Planning and Zoning Commission Meeting - Special AGENDA

**KETCHUM FIRE STATION DESIGN REVIEW
STAFF REPORT UPDATE
KETCHUM PLANNING AND ZONING COMMISSION
SPECIAL MEETING OF FEBRUARY 24, 2020**

PROJECT: Ketchum Fire Station

FILE NUMBER: P20-013

Figure 1: Sight Window Example

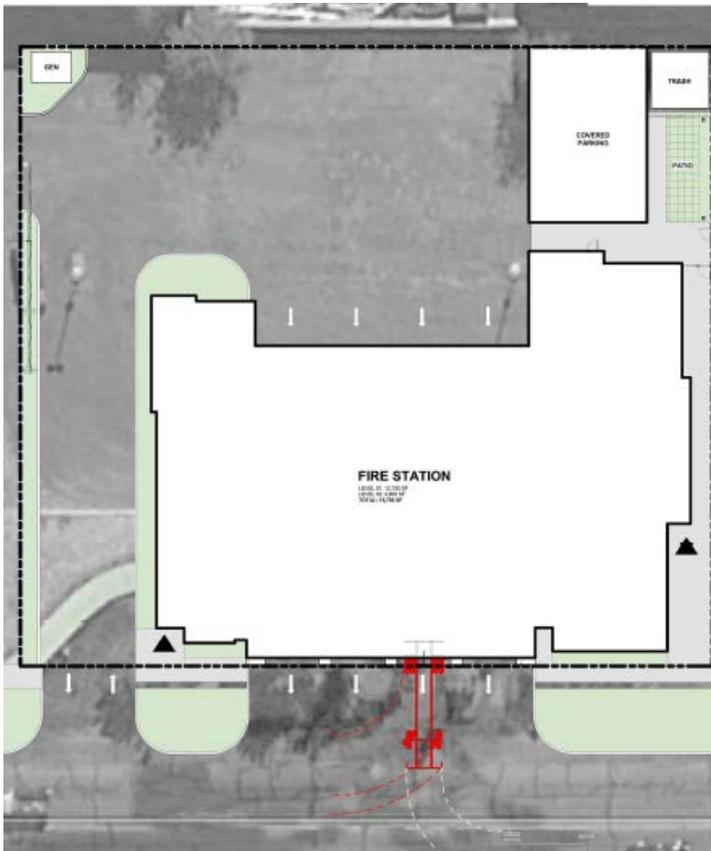
Neighboring Highway 75, Saddle Road, and Warm Springs Road, the fire station site is centrally located with easy access to main routes that connect to all areas of the City. The circulation plan includes drive-through apparatus bays and sight windows that enhance safety while minimizing the fire station's impact to neighborhood traffic.

3D PERSPECTIVE

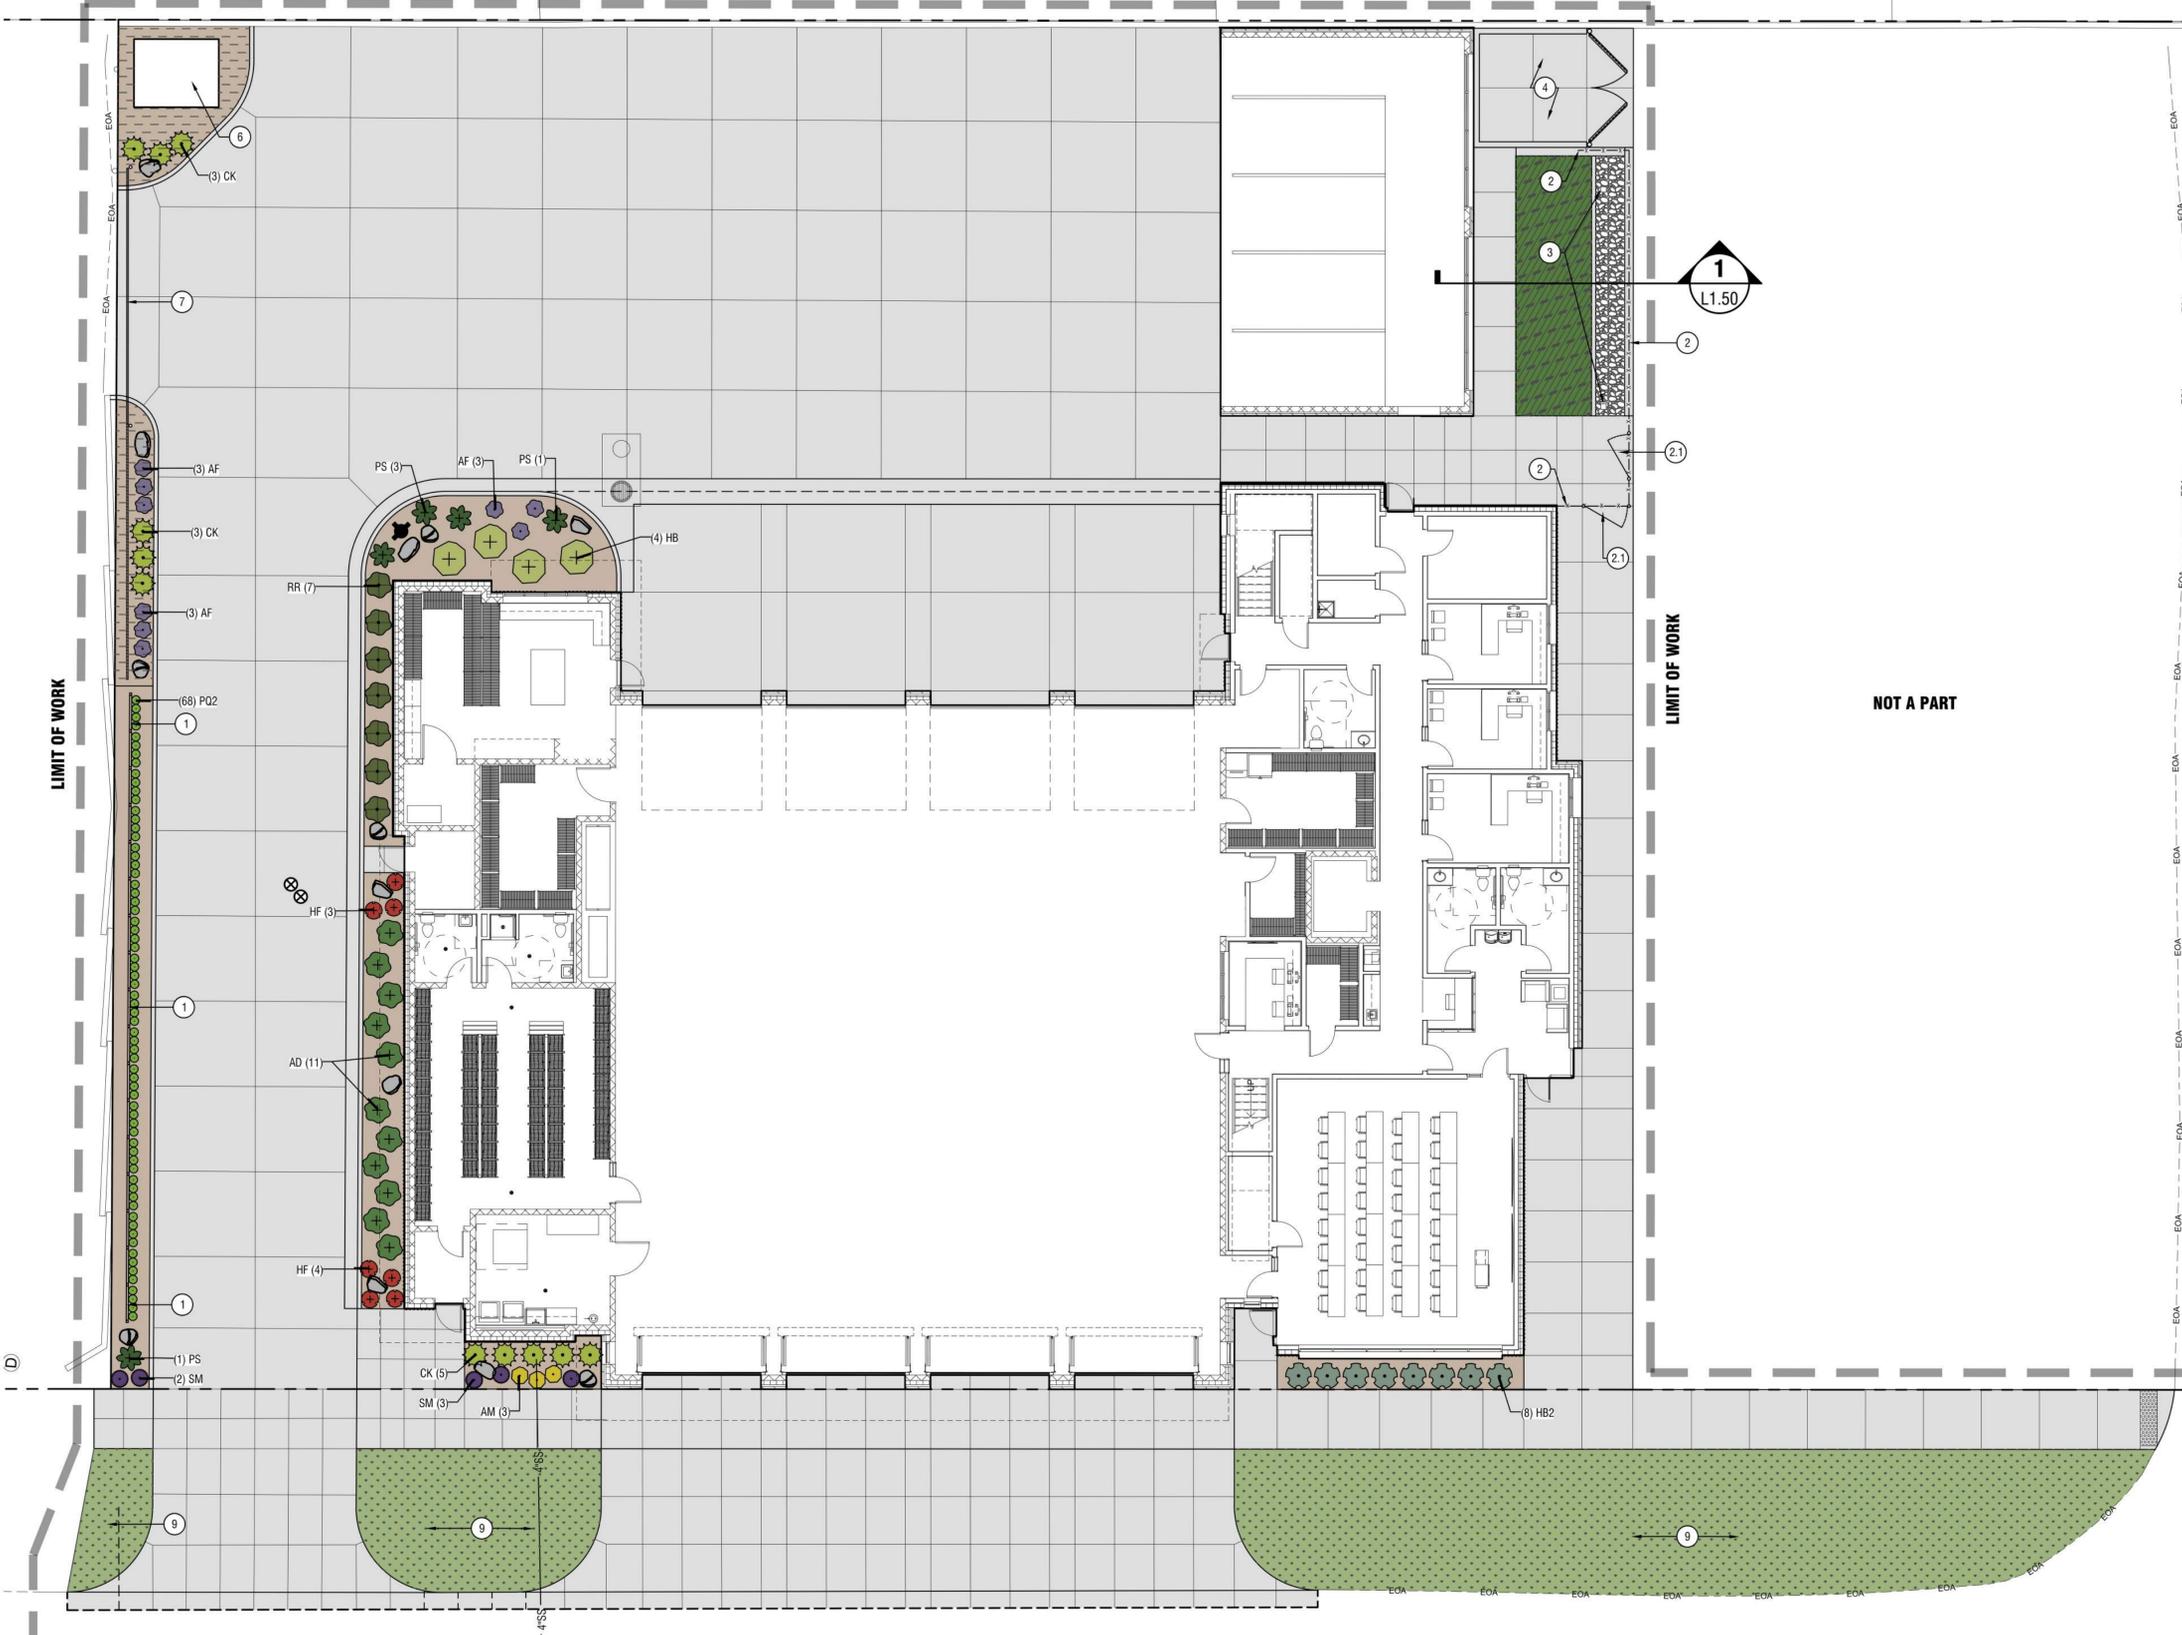
- A revised perspective to reflect the proposed design and landscaping. (Attachment A)

EXTERIOR ELEVATIONS

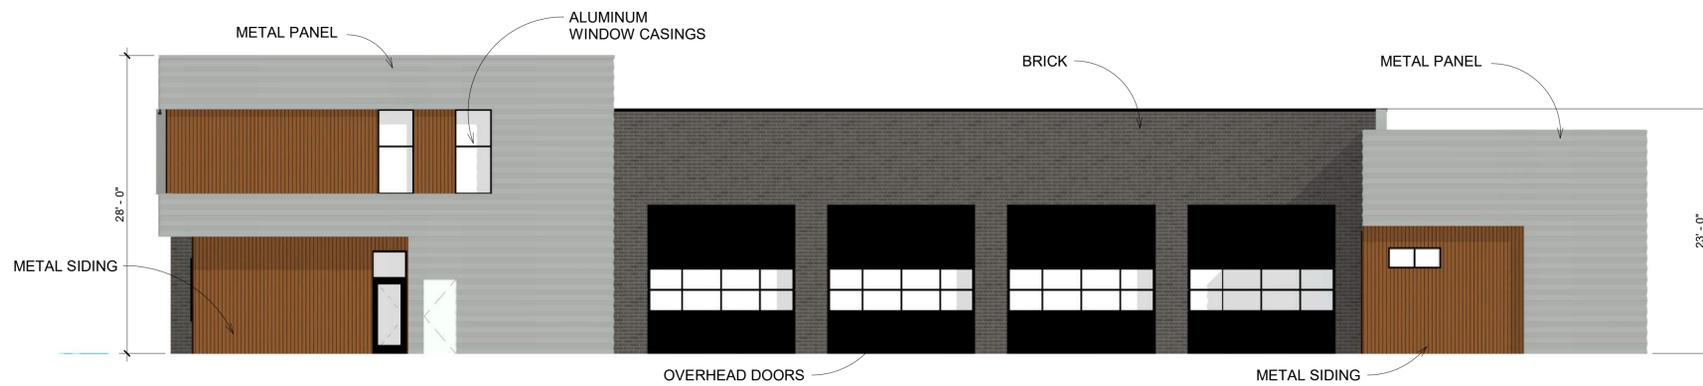
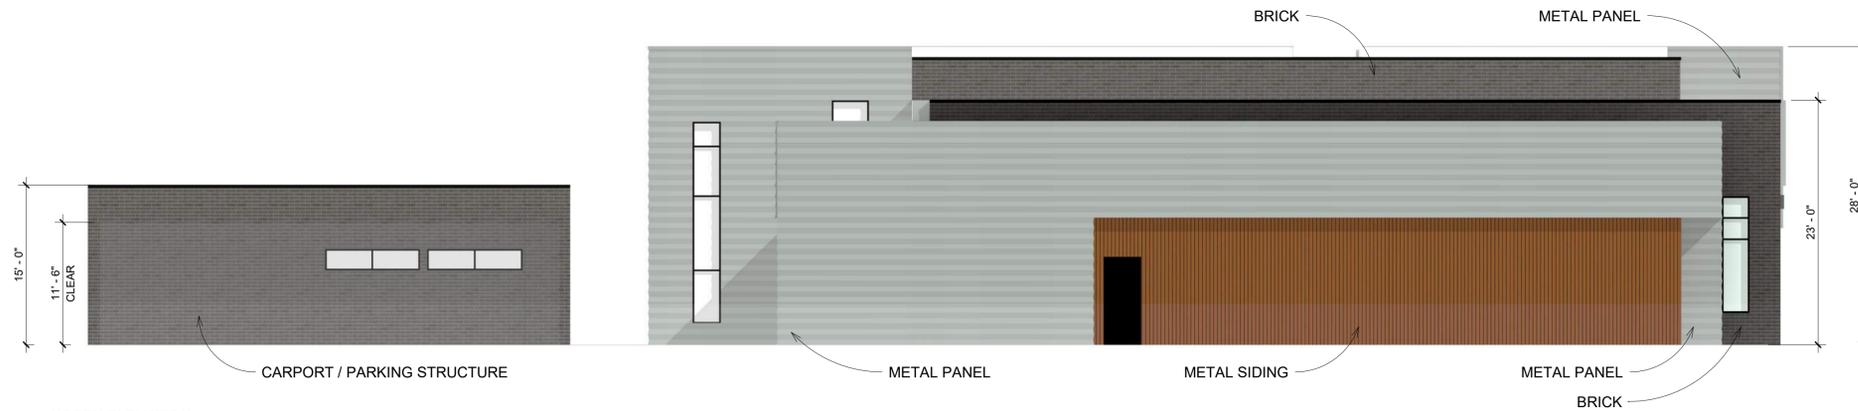
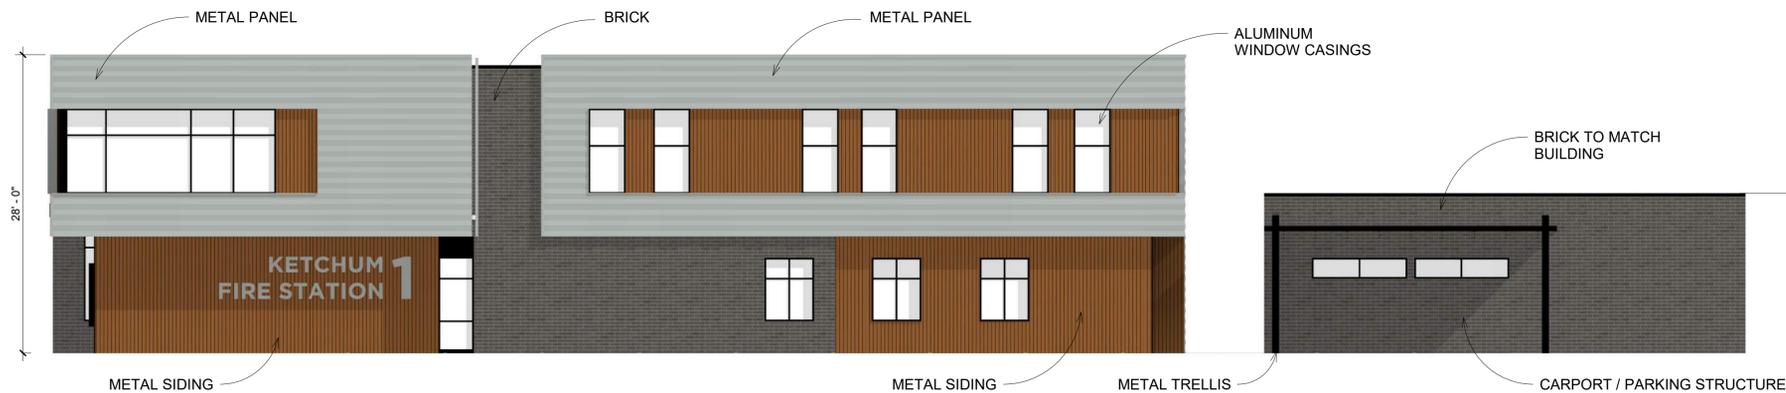
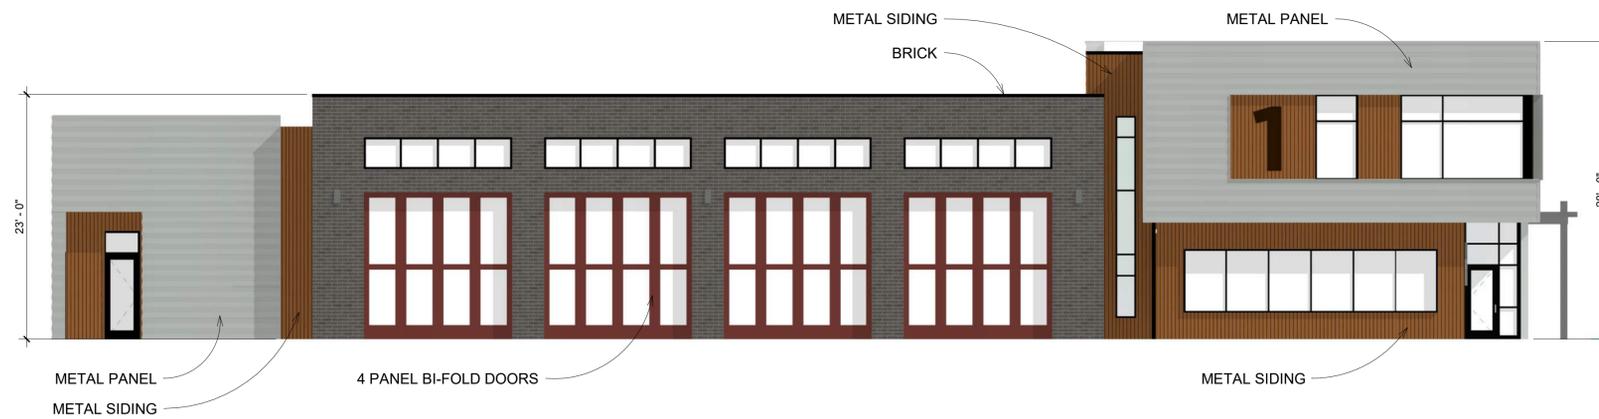
- Revised elevation and floor plans showing the height of the rear carport and removal of a window at rear elevation of the project (Attachment C)

Figure 3. Conceptual layout of warning sign locations that warn drivers and pedestrians/bicyclists.

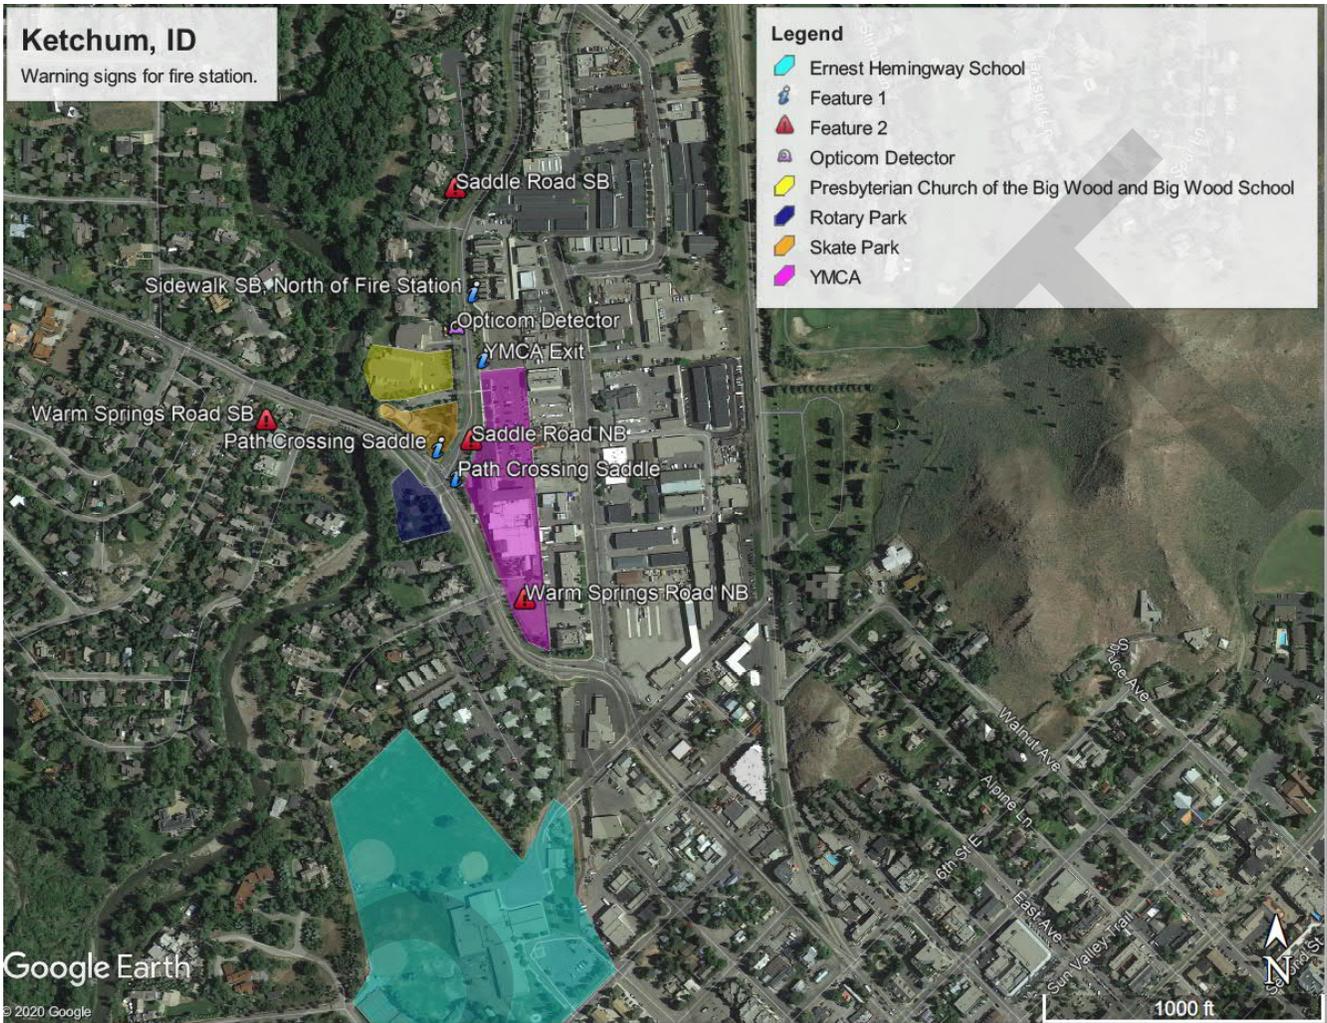
- A system can be installed that includes Fire Station Warning signs (W11-8) with flashing borders and/or flashing beacons to be activated when an emergency vehicle is leaving the fire station (see Figures 1 and 2). The signs would be deployed in strategic locations (such as trail crossings, locations near the Big Wood School or the YMCA, near transit stops, and on Saddle Road and Warm Springs Road, see Figure 3) that would alert pedestrians and bicyclists to the presence of an emergency vehicle.¹ Smaller signs are recommended for pedestrian/bicyclist applications.
